**Responsible Authority Report
- 78/2014/A**

Form 2 - Responsible Authority Report

Property Location:	Lot 1010 (9) Hawksburn Road Rivervale
Application Details:	85 Dwellings (75 Multiple Dwellings and 10 Grouped Dwellings)
DAP Name:	Metro Central JDAP
Applicant:	Rowe Group
Owner:	Statesman Homes Pty. Ltd.
LG Reference:	78/2014/DAP/A
Responsible Authority:	City of Belmont
Authorising Officer:	Neville Deague – Director Community and Statutory Services
Department of Planning File No:	DP/14/00141
Report Date:	Submitted to DAP on 30 September 2014
Application Receipt Date:	11 August 2014
Application Process Days:	35 Days
Attachment(s):	<ol style="list-style-type: none"> Joint Development Assessment Panels Approval (7 May 2014) Amended Development Plans and Supporting Information from Applicant (11 August 2014)

Figure 5: Amended Car Parking and Access Configuration

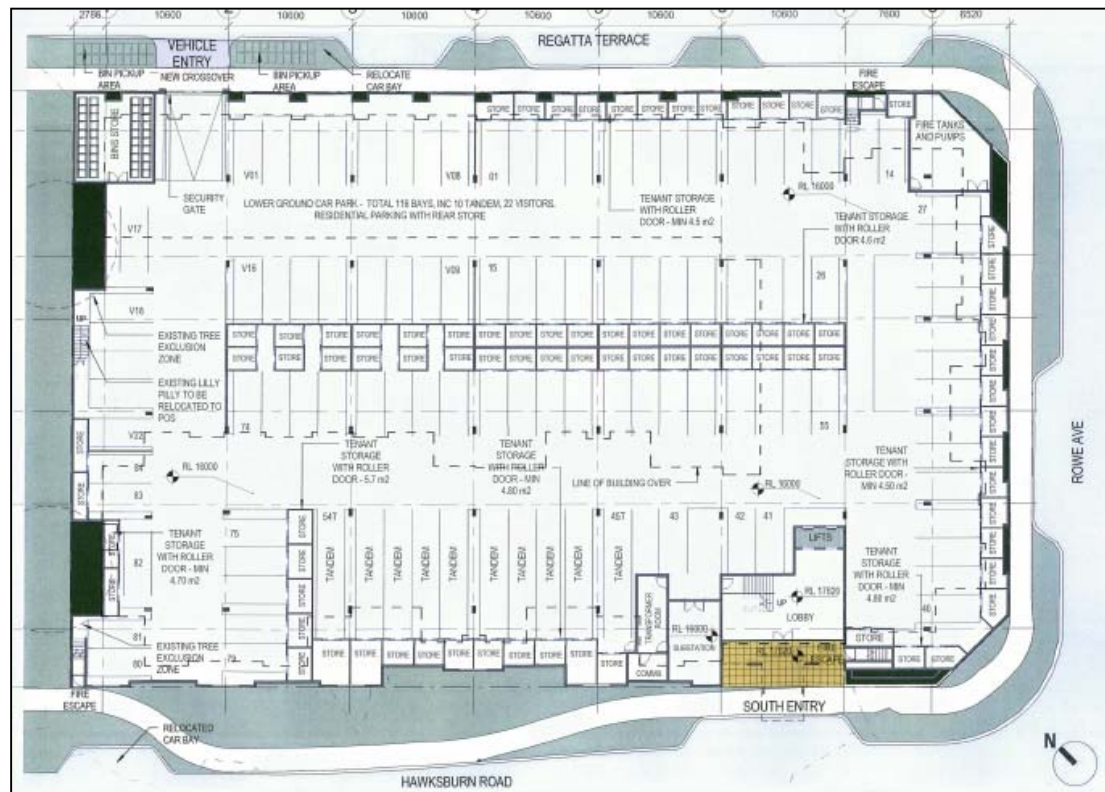
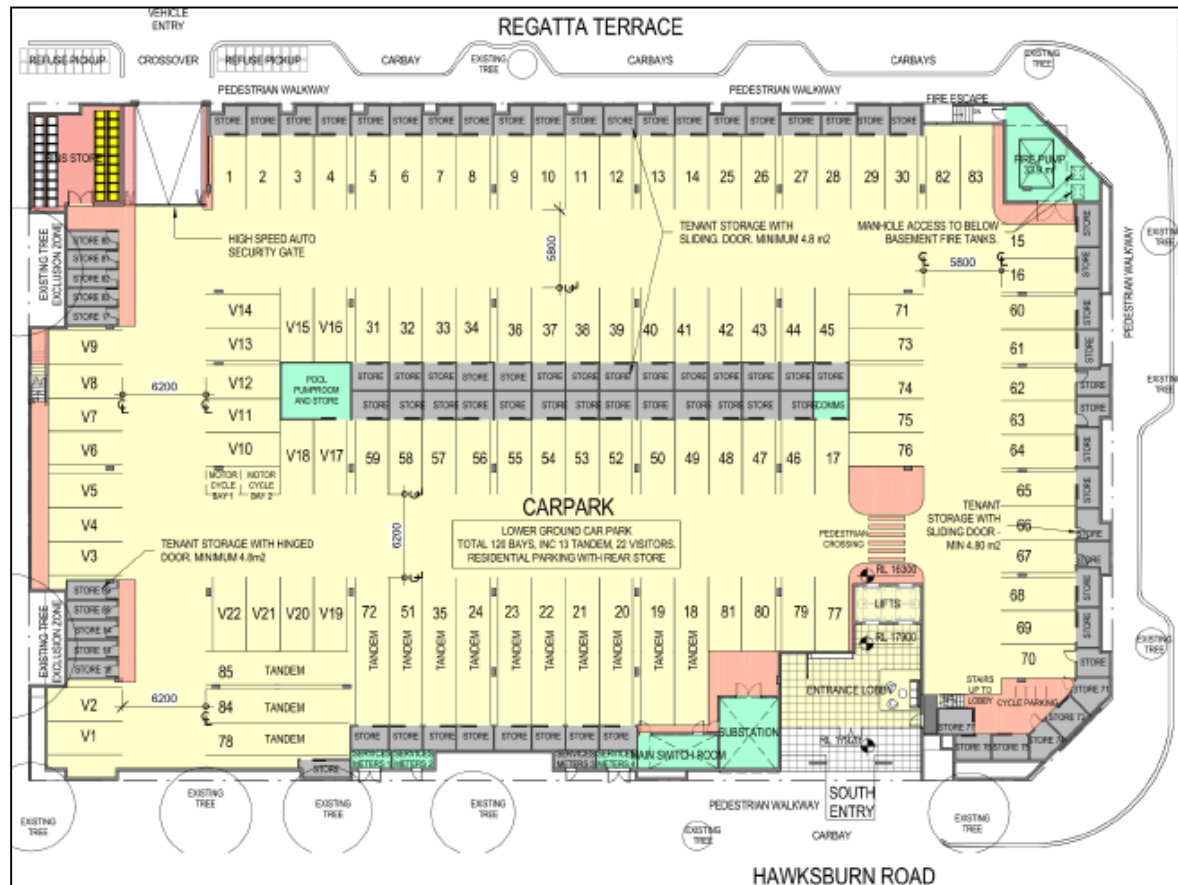
The applicant has made some minor modifications to the plans to improve the overall design of the development. The first of these modifications was to the car parking and access configuration. The reconfiguration of the car parking and access area has resulted in an increase in the number of car parking bays from 114 to 120. This includes 98 resident bays (four more than previously approved) and 22 visitor bays (1 more than previously approved). With the modification of the car parking layout the application now includes a surplus of 18 car parking bays. The City's Technical Services Department have reviewed the revised lay out and are supportive of it.

The reconfiguration has allowed the removal of one resident bay (Bay 82) and one visitor bay (V17) which were previously not supported as they were not considered to be functional. This has in turn removed the requirement for Condition 15 which was to ensure these two bays were deleted from the plans and the remaining car parking reconfigured accordingly.

The proposed alterations do not increase the plot ratio or building bulk, and therefore have little impact on the overall development other than to increase the amenity for future residents. For this reason the modifications to the approved plans and the removal of Condition 15 are considered to be acceptable and are supported by the City.

Parking Configuration (Basement – Plan A200)

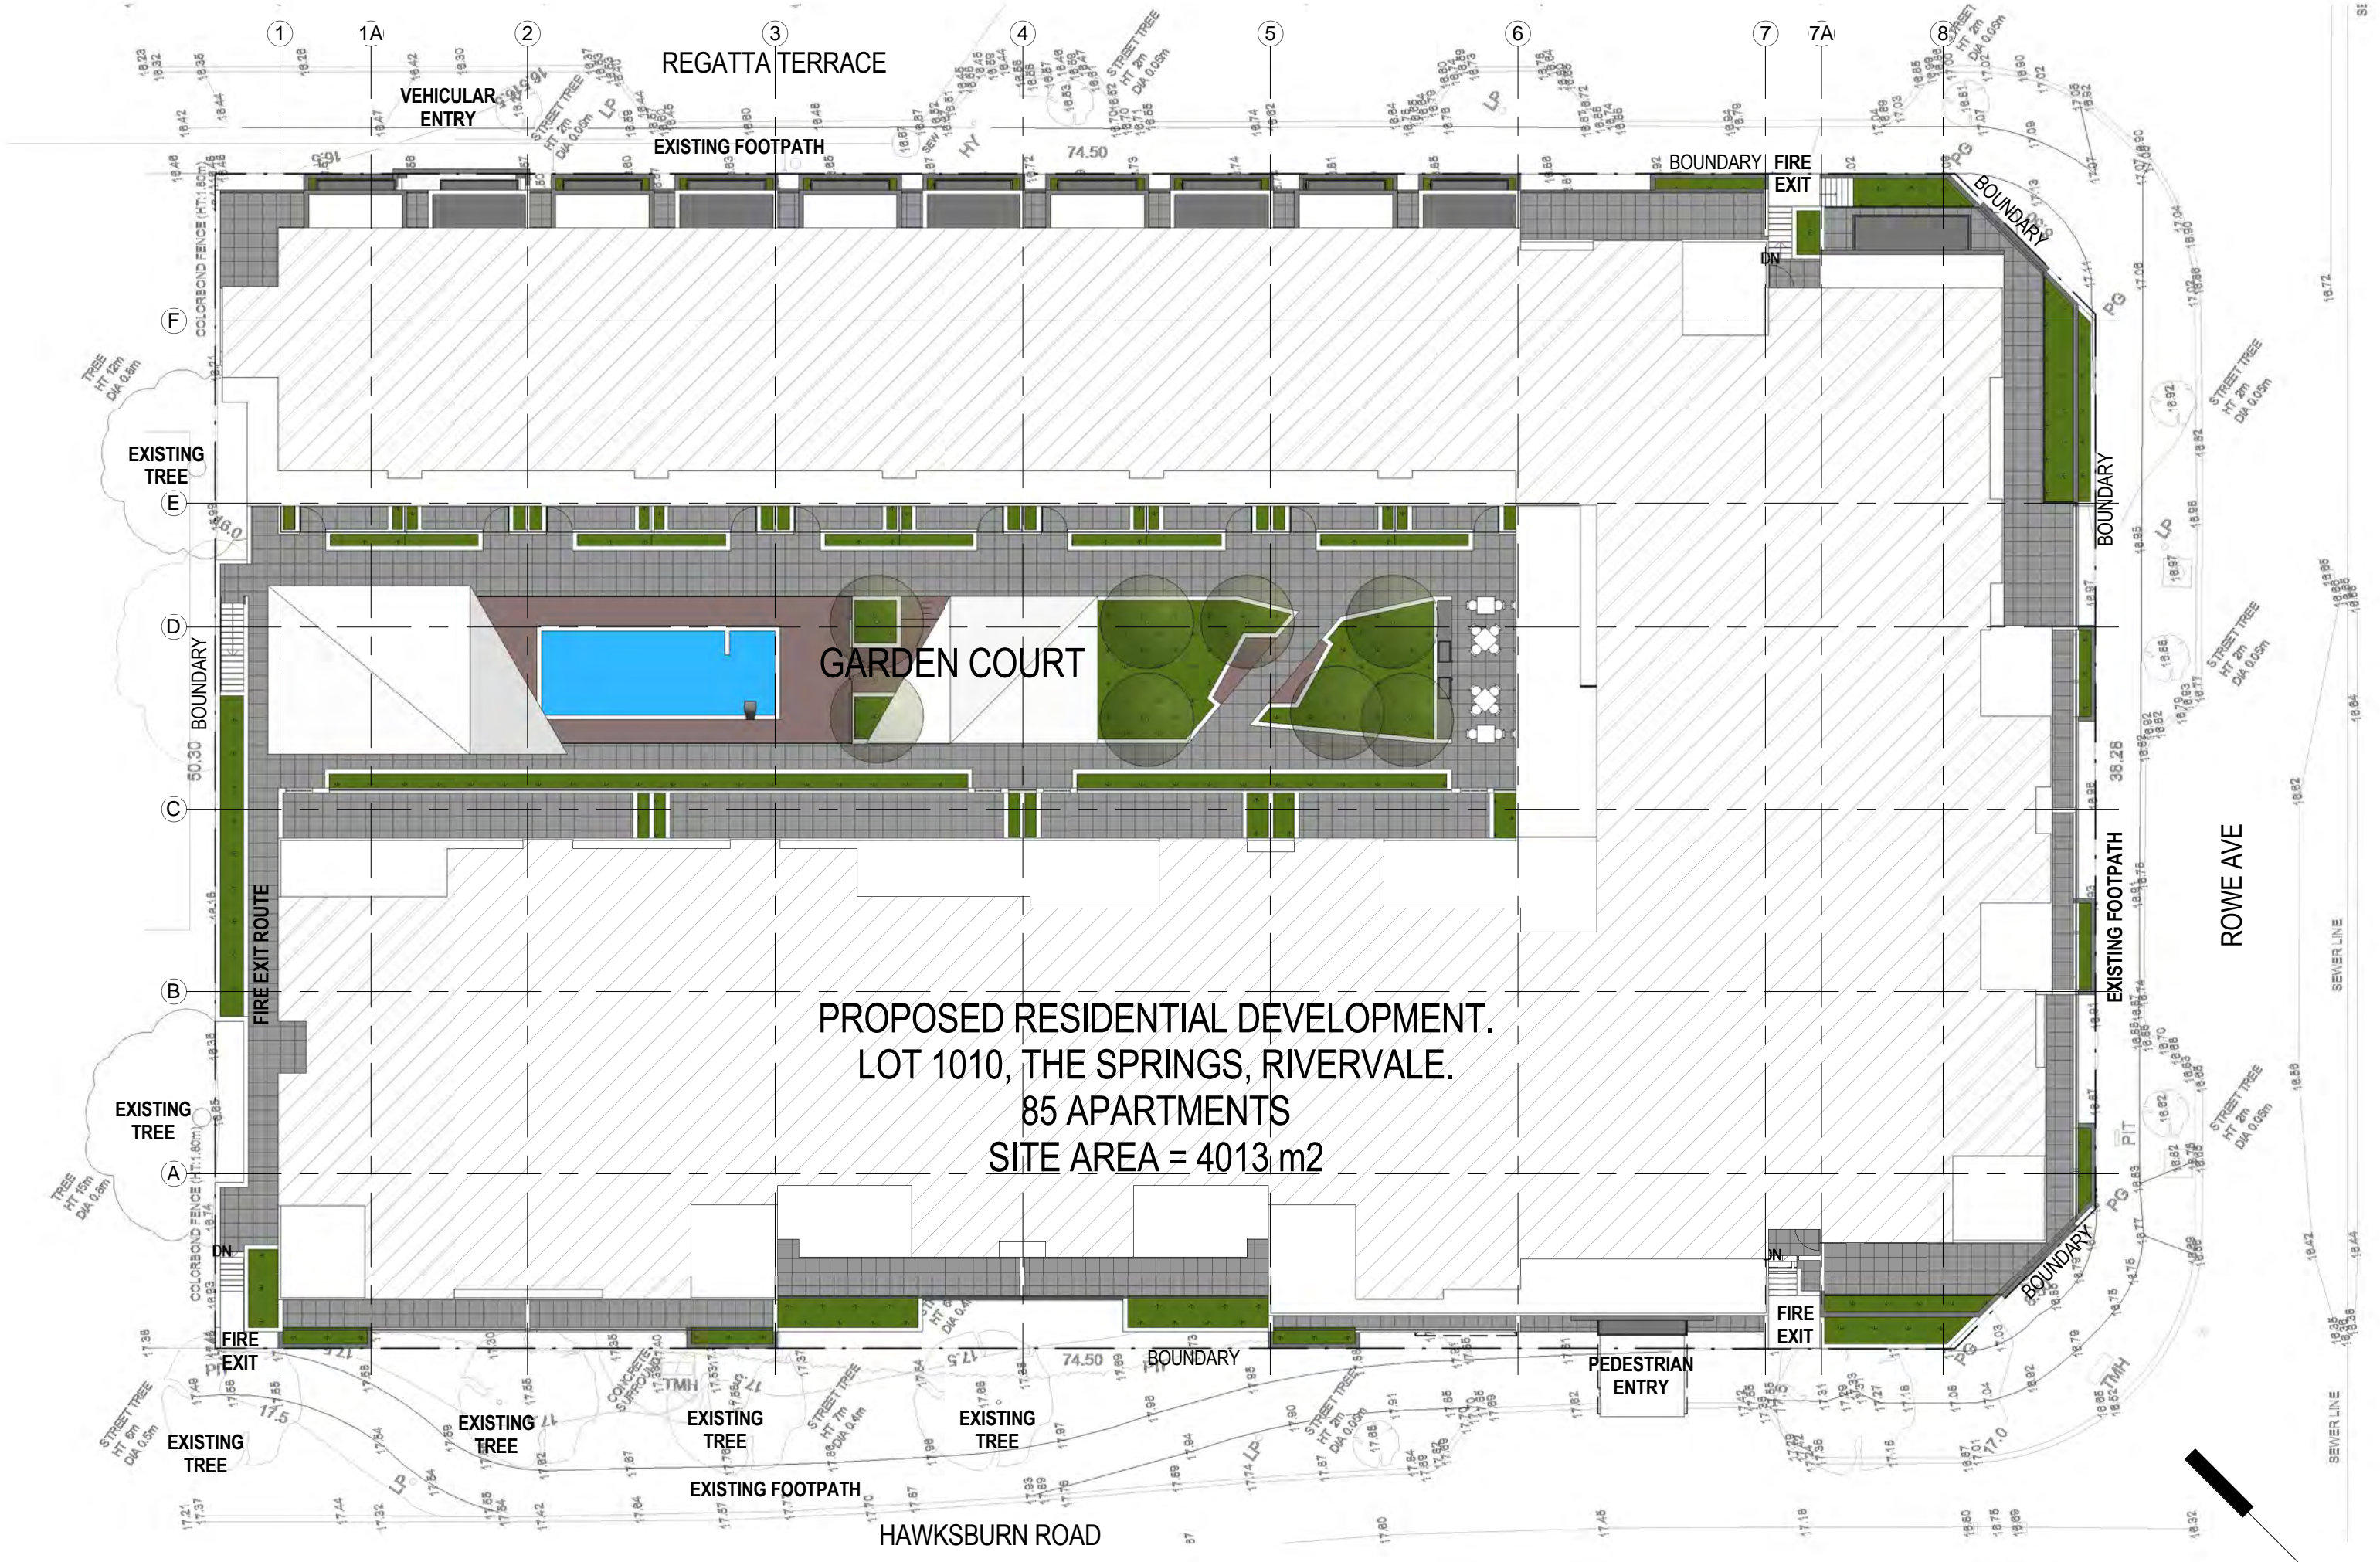
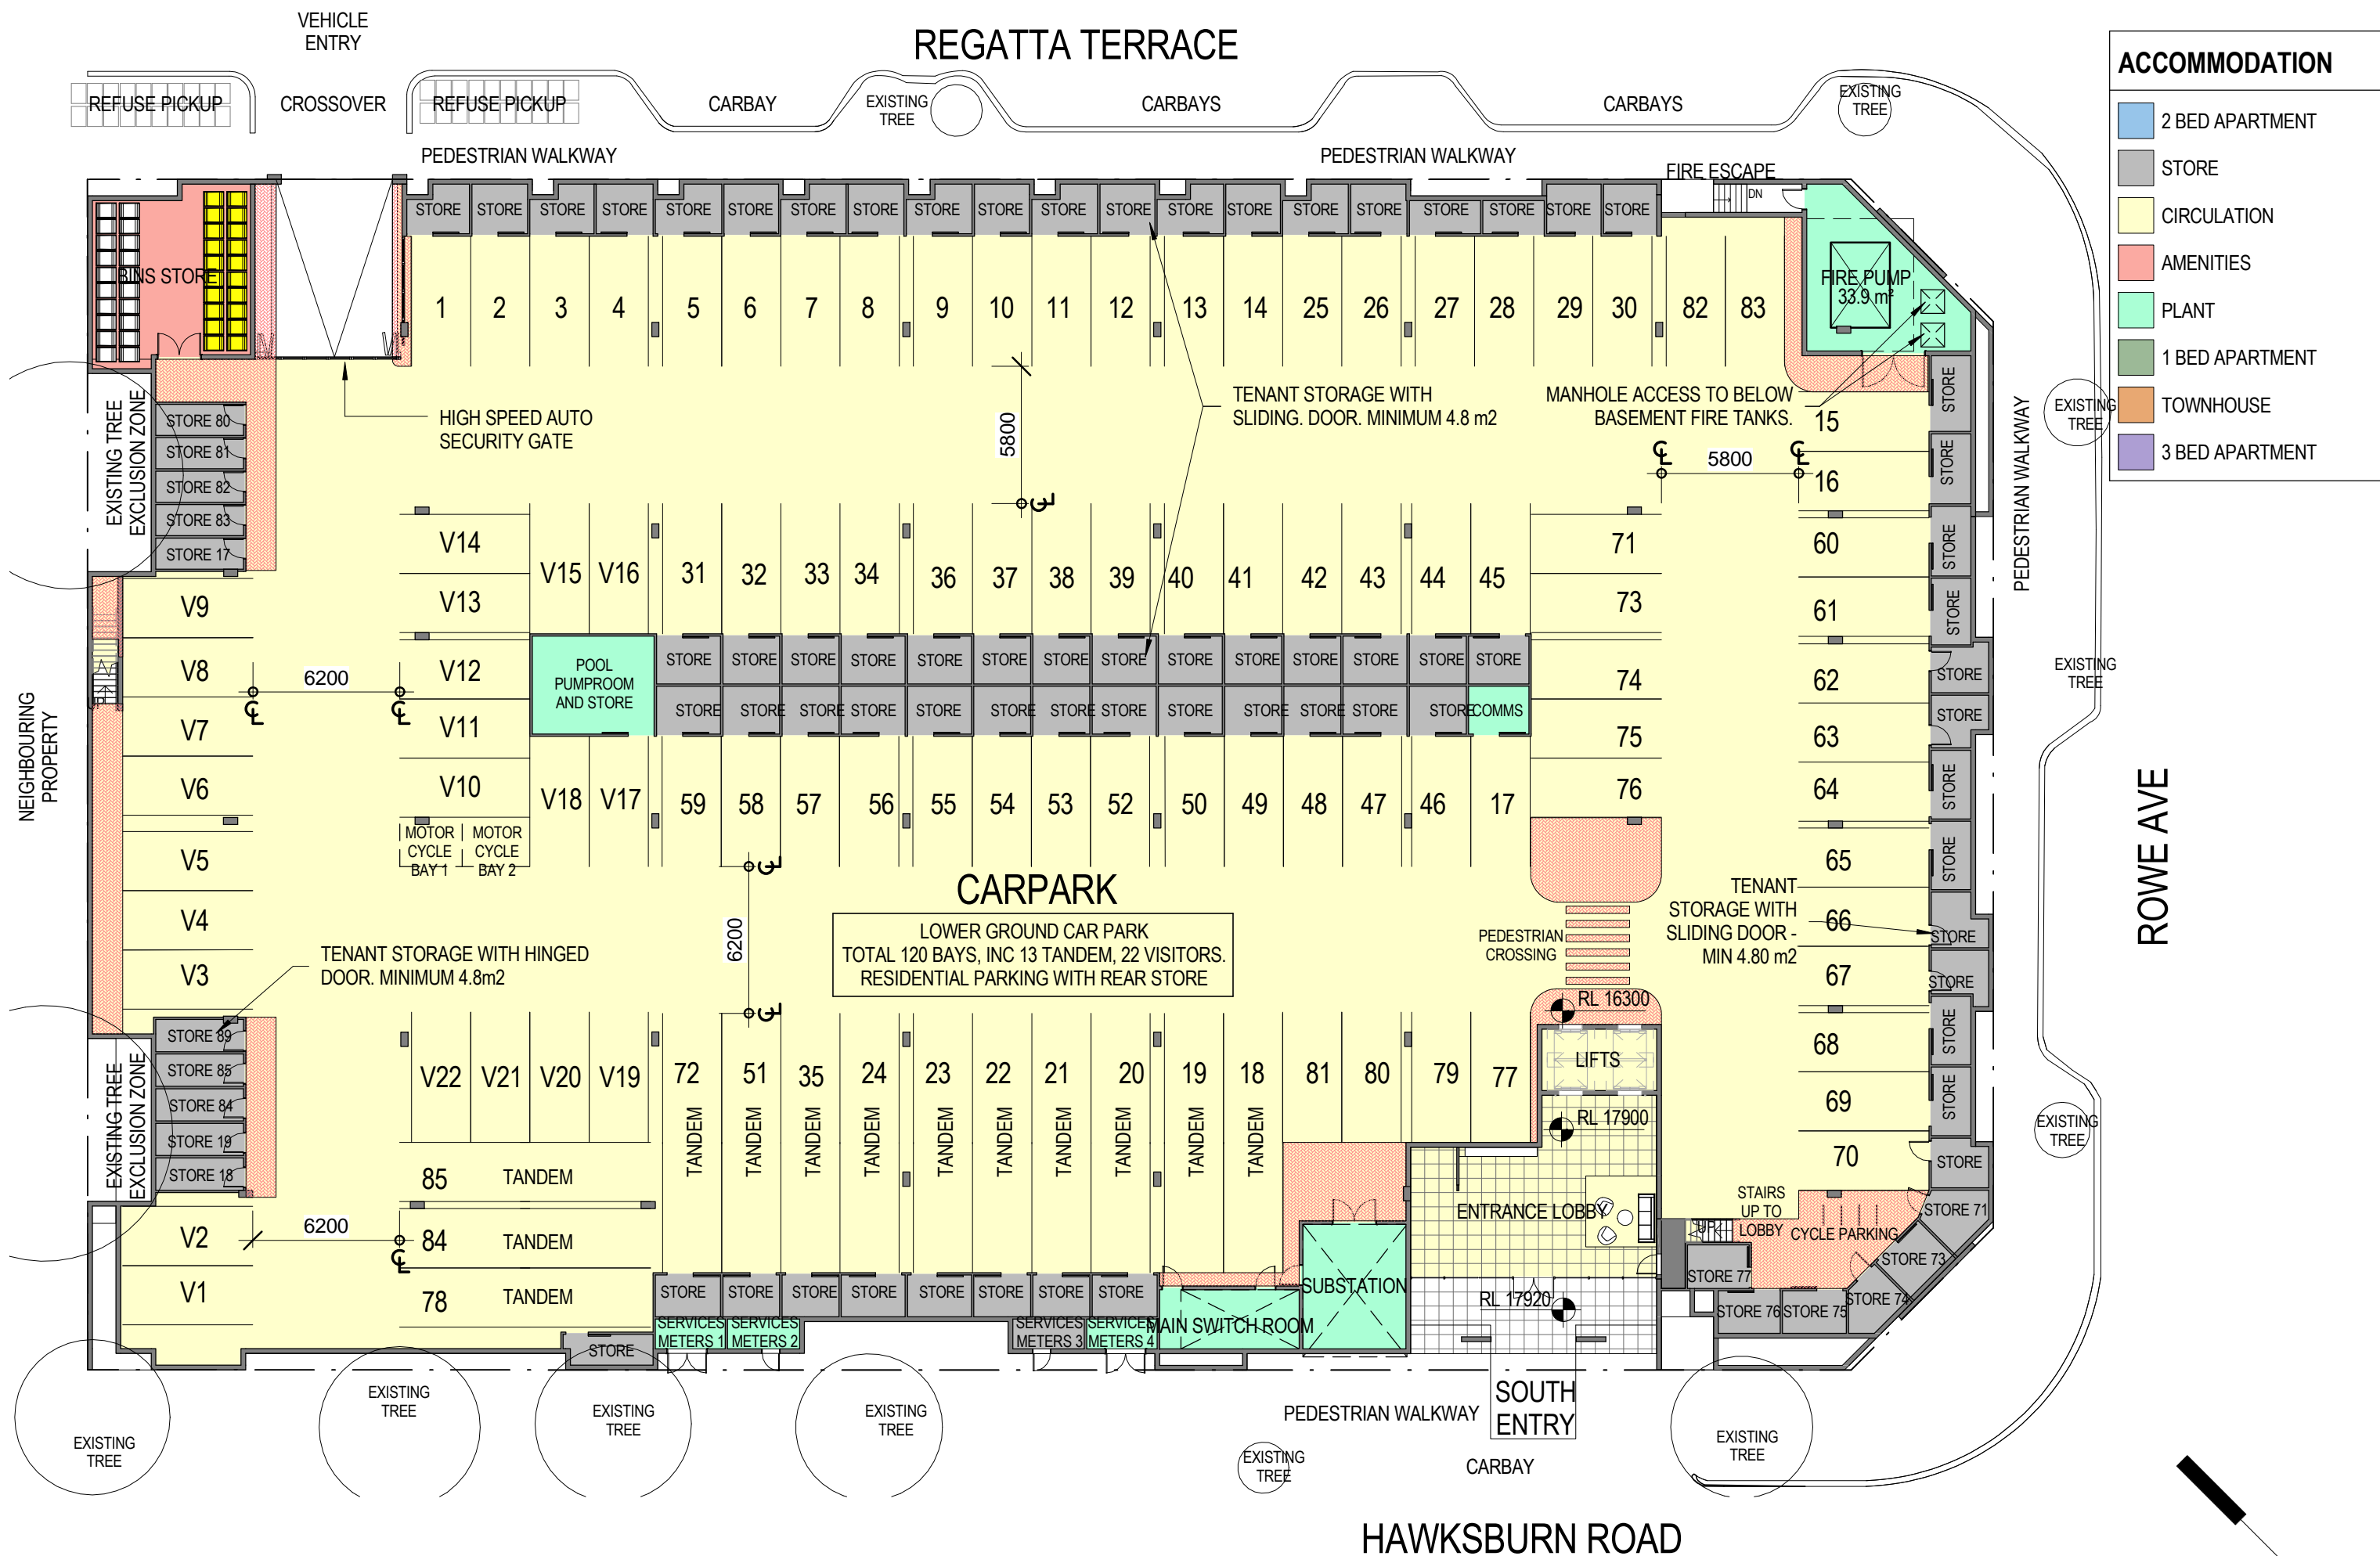
The basement car parking has been redesigned to remove the parallel car parking bays V17 and 82 (as per the originally approved plans). Given the subject car parking bays have been removed, we request the deletion of Condition 15 which is now superfluous.
